**Ordinance Number: 1365-23, File Number: 19-24**

**RTA Tunnel Membrane Replacement- Addendum 3**

**NARRATIVE:** Addendum 3 contains the following:

POINT	STATION	OFFSET	
A	16+99.24	36.90	R
B	16+99.51	2.00	R
C	16+99.75	-4.85	L
D	16+82.20	-24.97	L
E	16+72.61	-25.15	L
F	16+72.60	-36.98	L
G	17+89.24	-36.27	L
H	17+89.45	-23.94	L
I	17+80.66	-24.04	L
J	17+61.49	-5.27	L
K	17+61.35	2.00	R
L	17+60.07	38.73	R

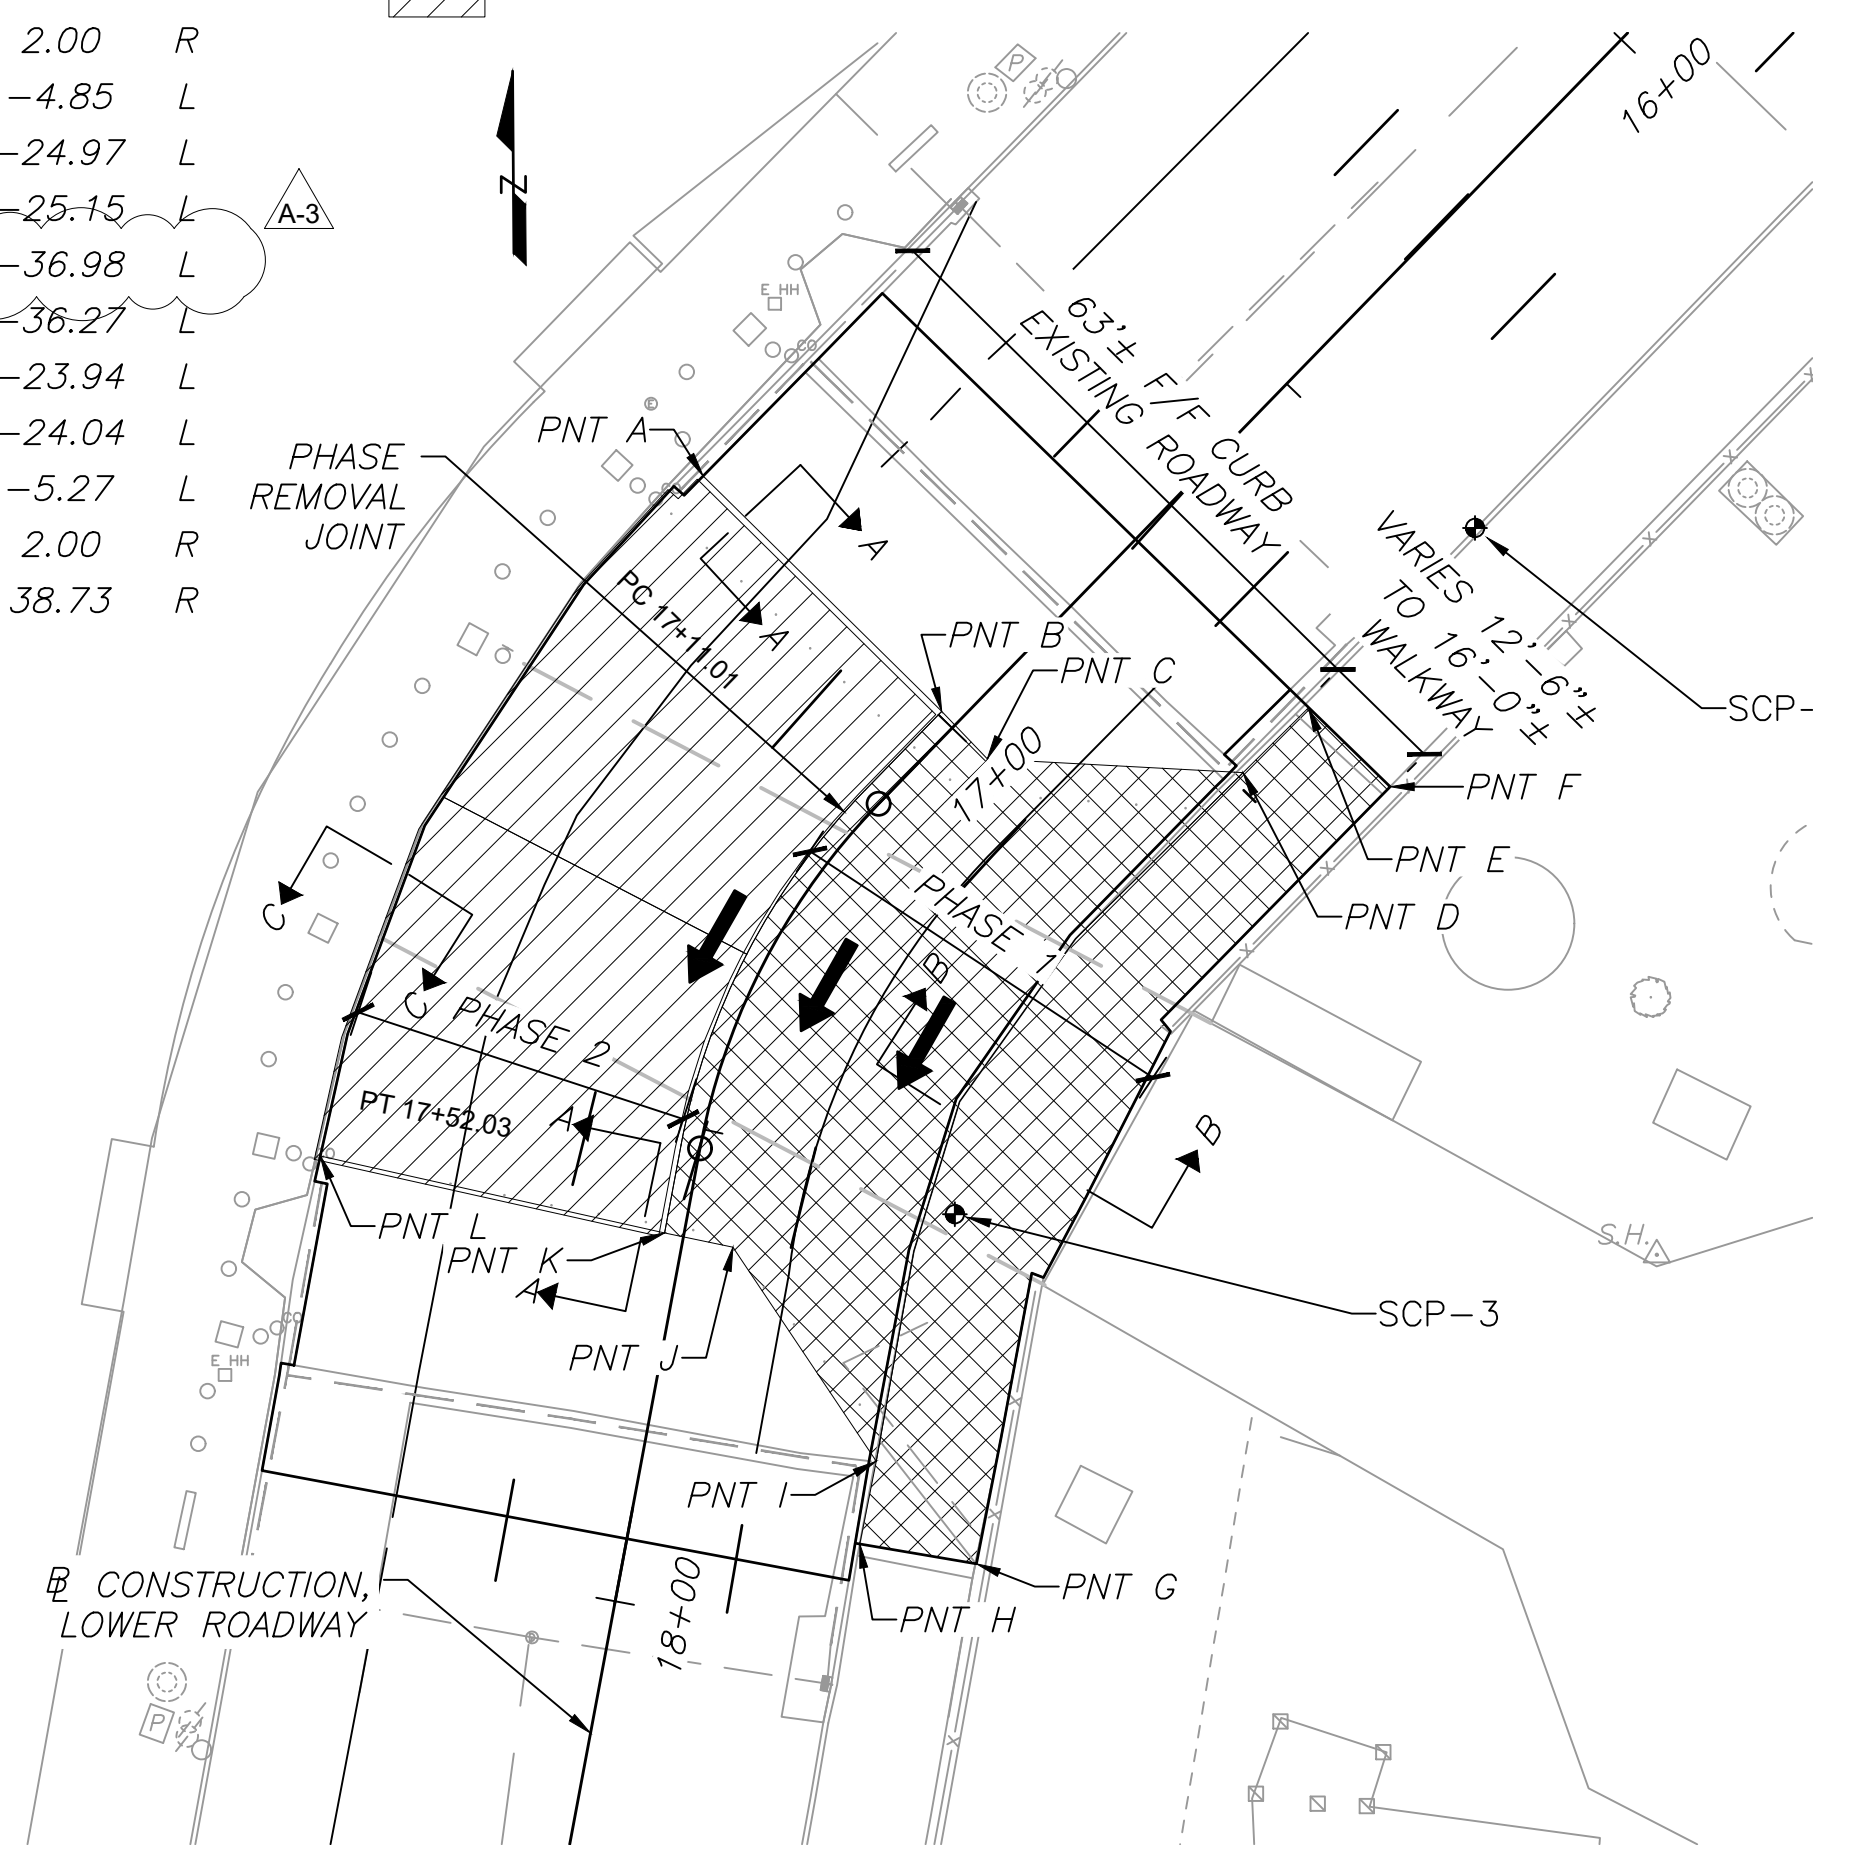
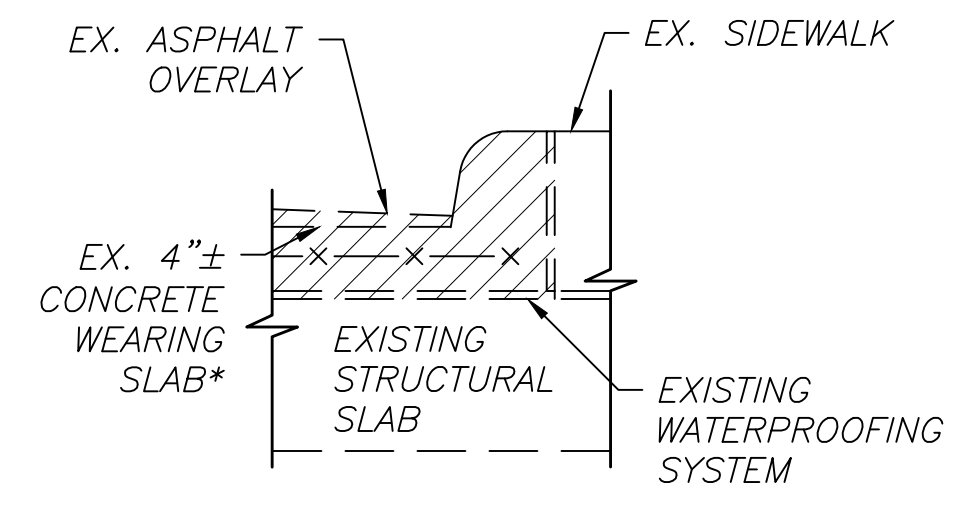
NOTE: ENTIRE SHEET REVISED FOR ADDENDUM A-3.

Date: FEBRUARY 2024 Sheet: C-17

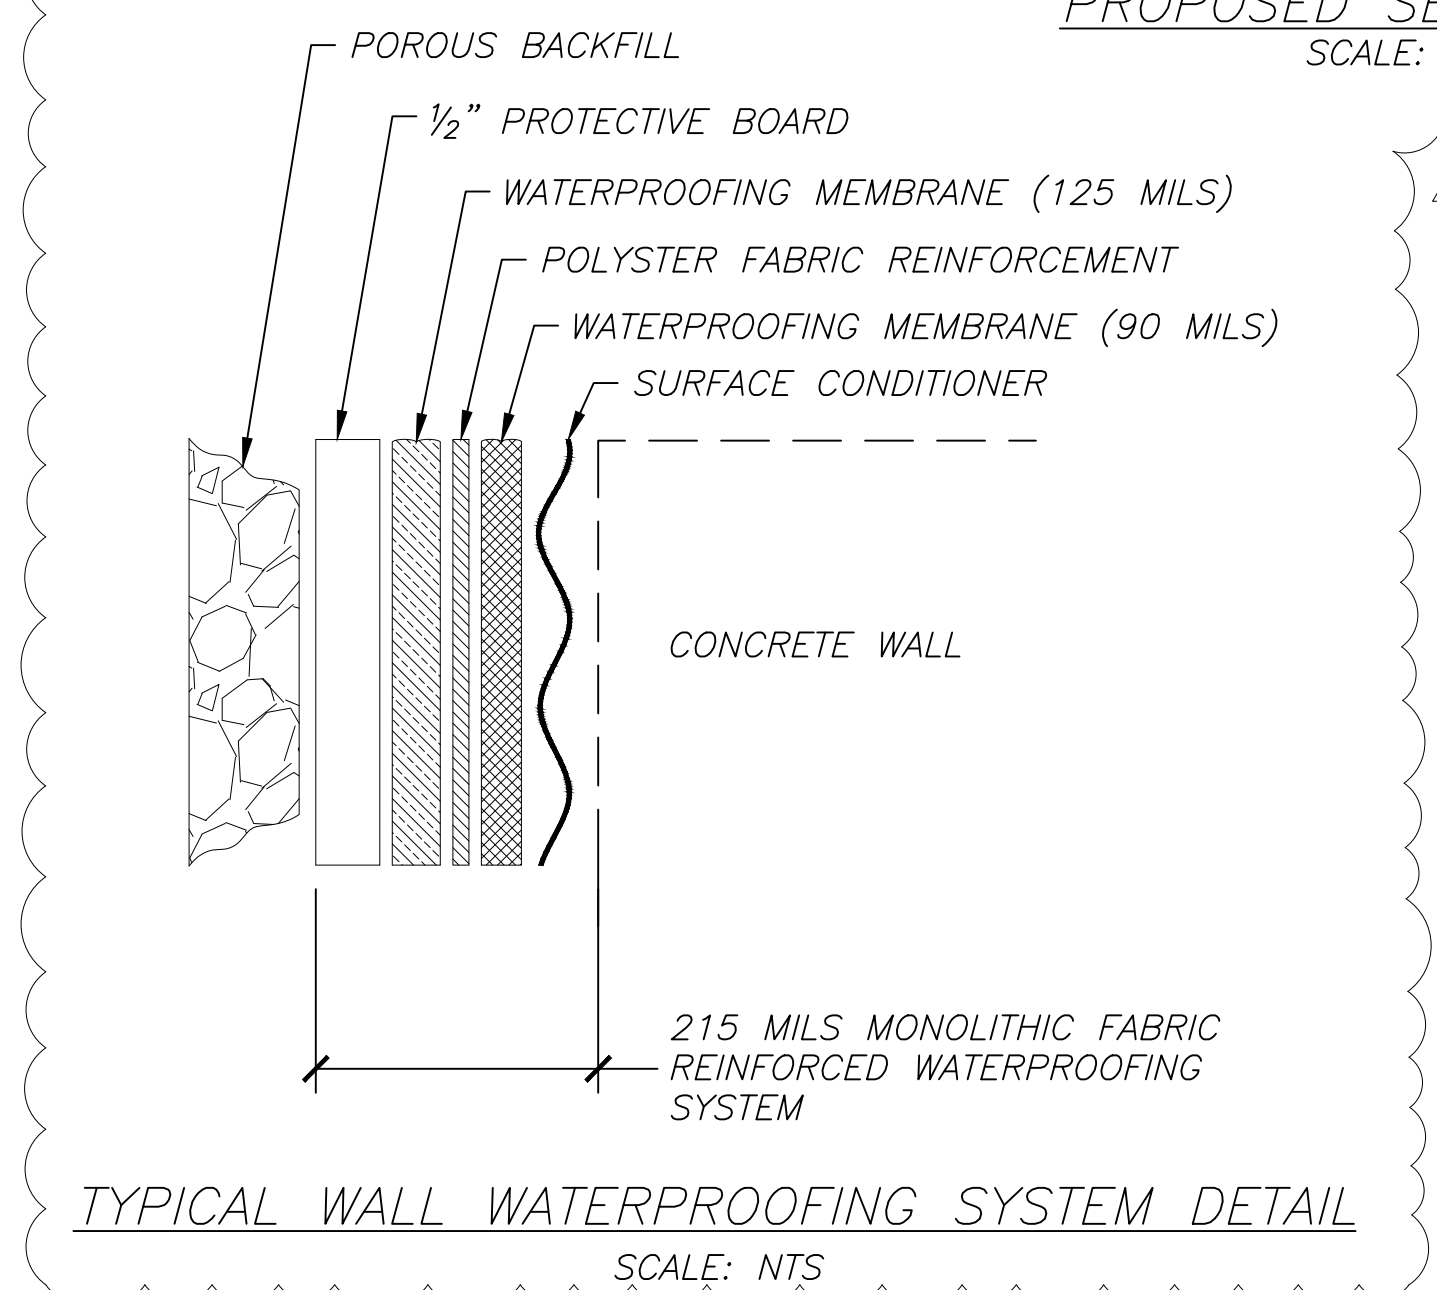
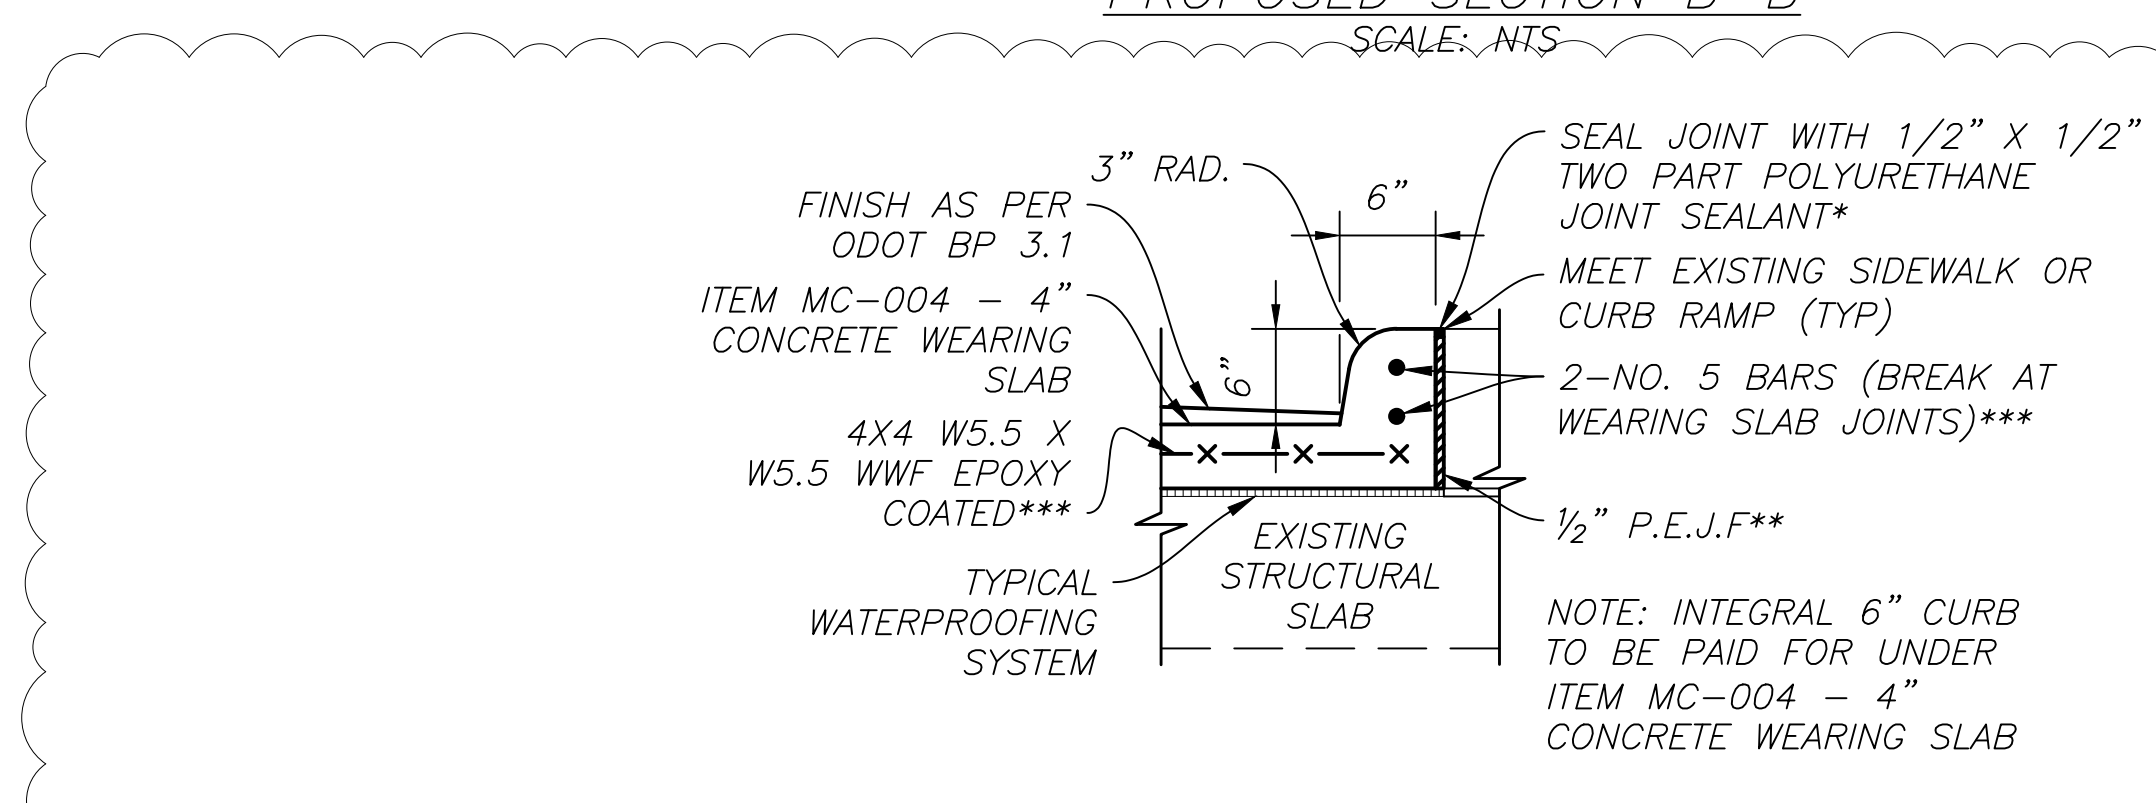
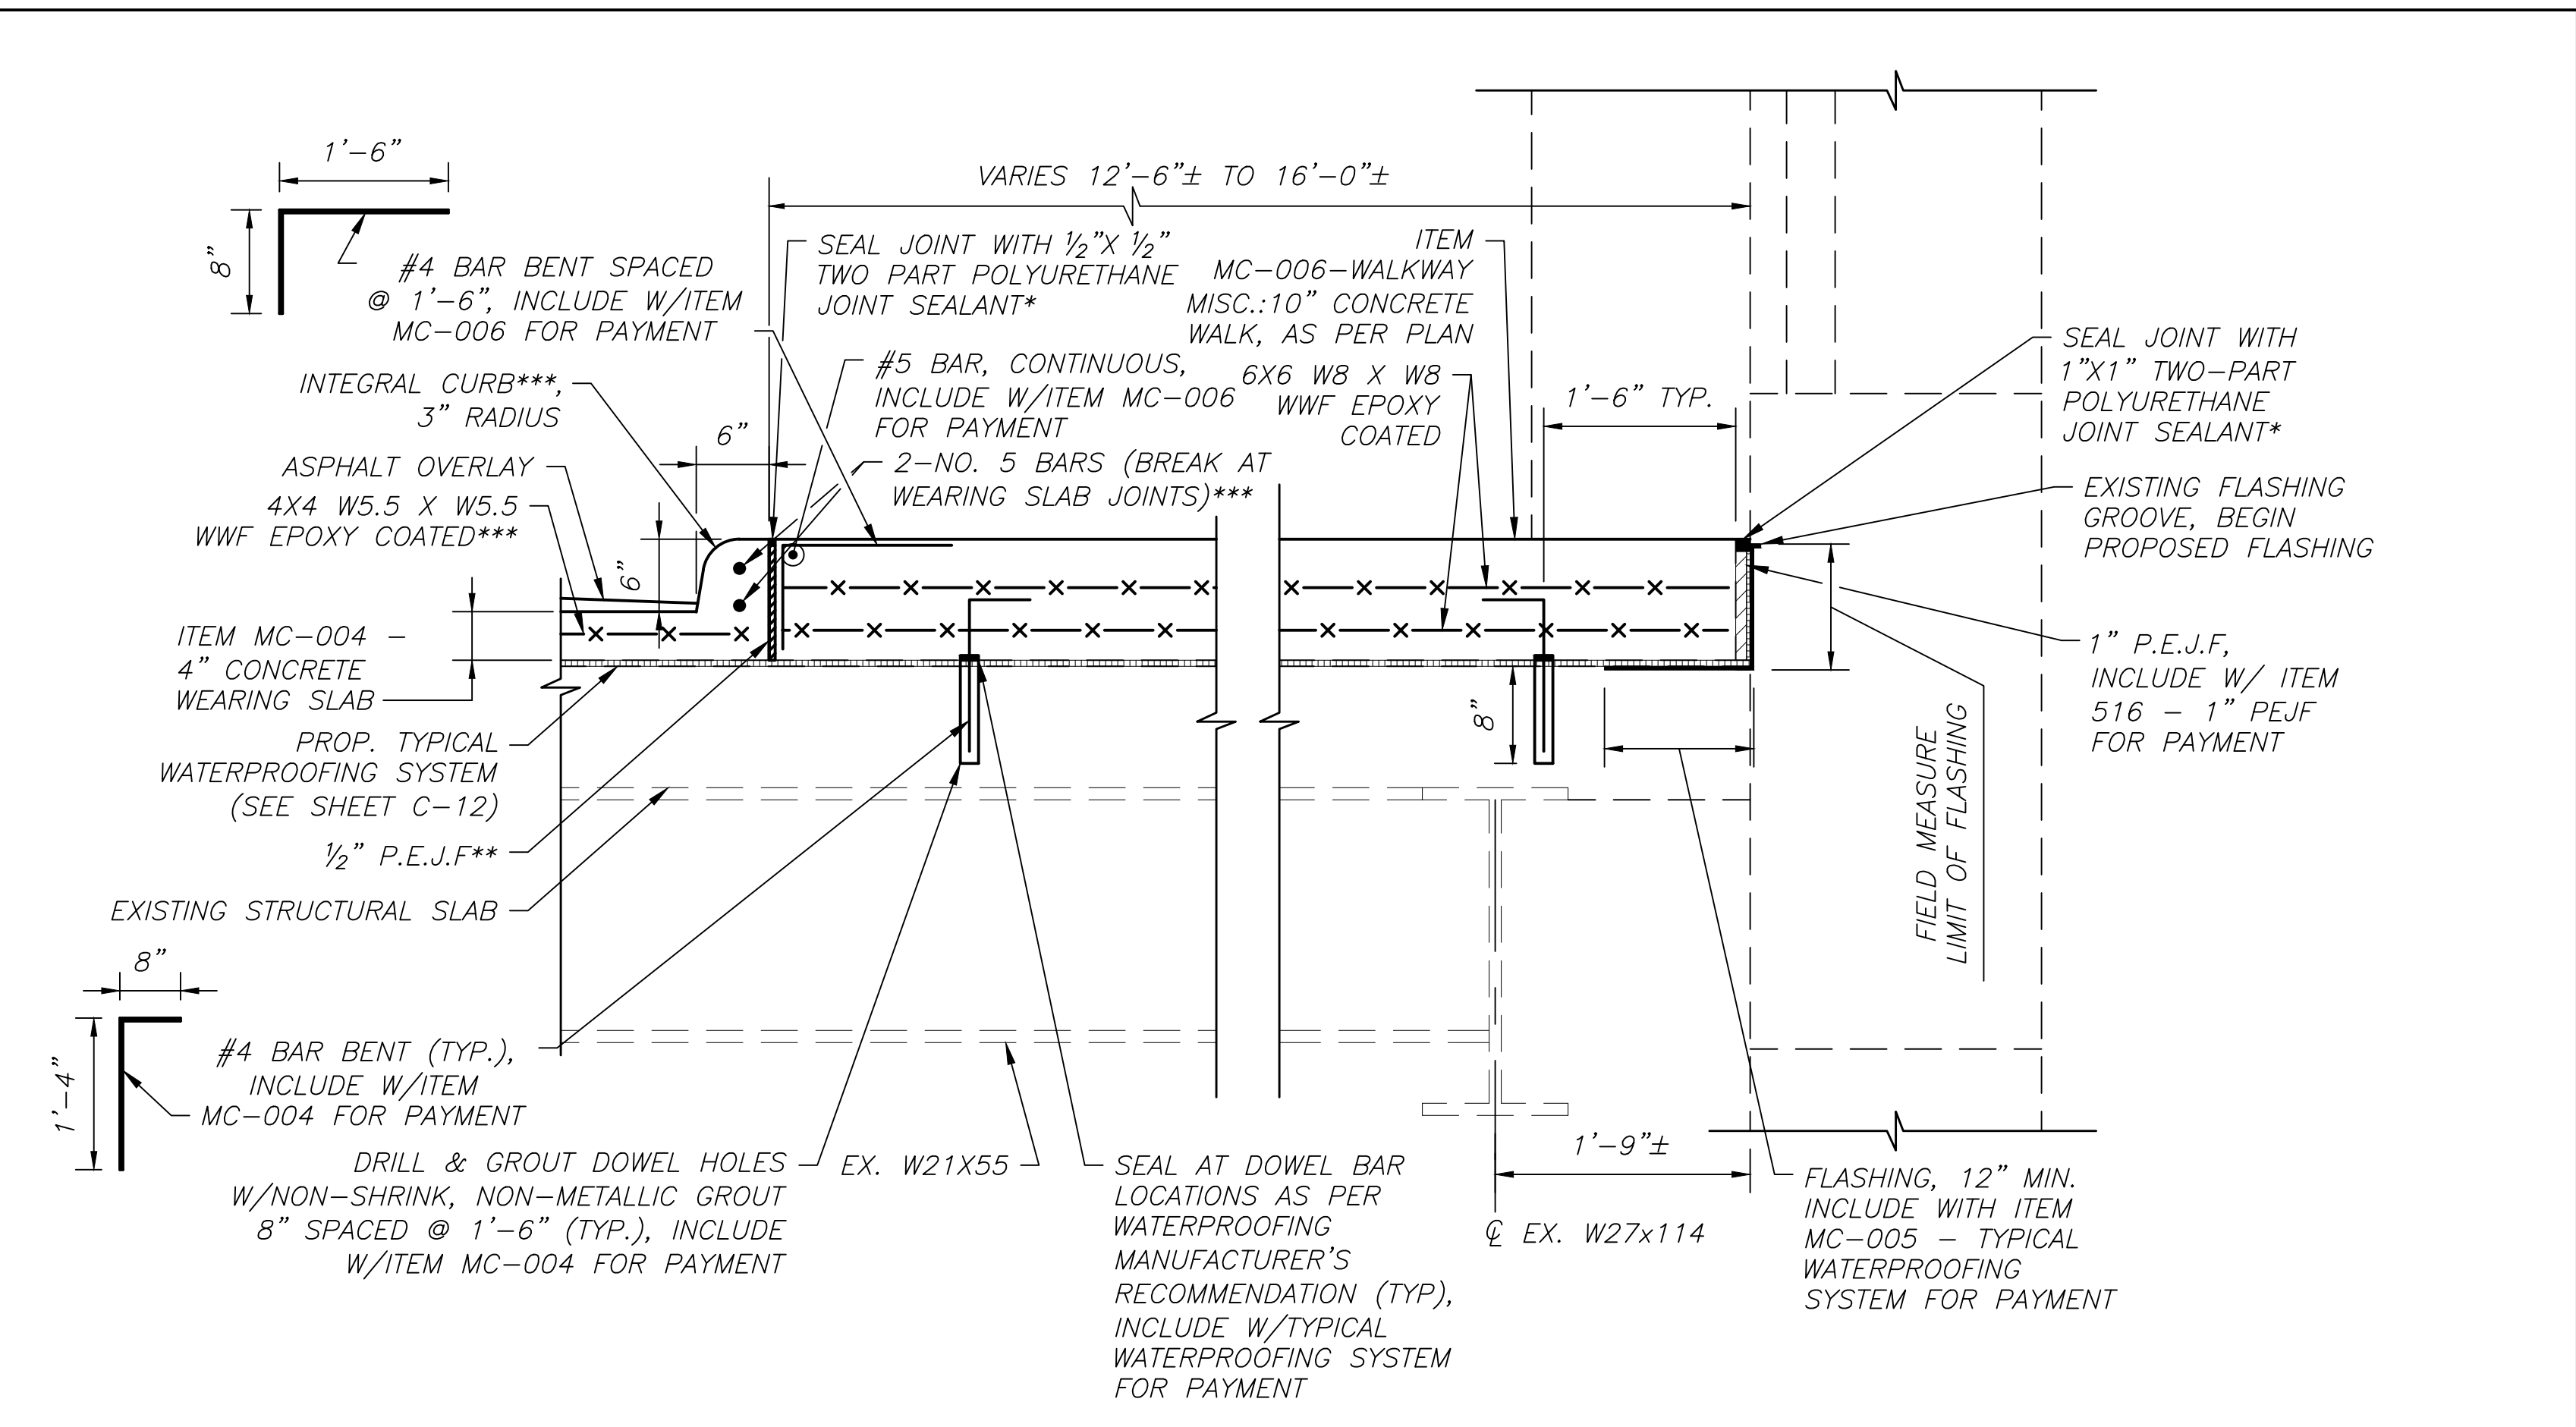
Question: Plan Sheet C-17, Foam Flashing Detail, states to provide "premolded joint material". Please provide specified type and size to be installed.

*Answer: The foam flashing detail has been removed. Please see Sheet C-19 for flashing details.*
